Masks Need MWO

Unfortunately, many M40/M42s are still waiting for MWO 3-4240-347-20-1 (Jun 98). It's simple to check if your masks have been modified, NBC NCOs. Look at the outlet valve. If a zip tie has been fastened around the valve, the MWO's been done.

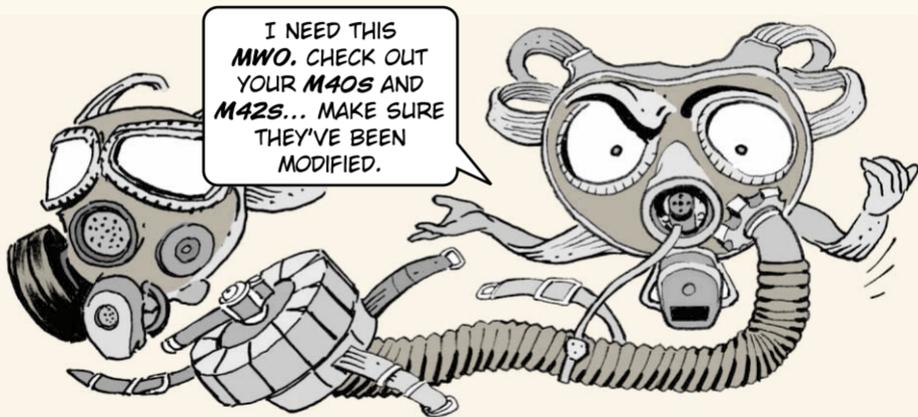
The tie should go against the face piece behind the drink tube nipple. If it's anywhere else on the valve housing, the tie can't prevent the housing from separating from the facepiece.

When you put on the zip tie, remember to put the tab of the tie in the 6-9 o'clock position. If you try to put it in the 12-6 position, the drink tube gets in the way.

The zip tie is easier to install if you pull it hand-tight before using the tensioner tool to fully tighten it.
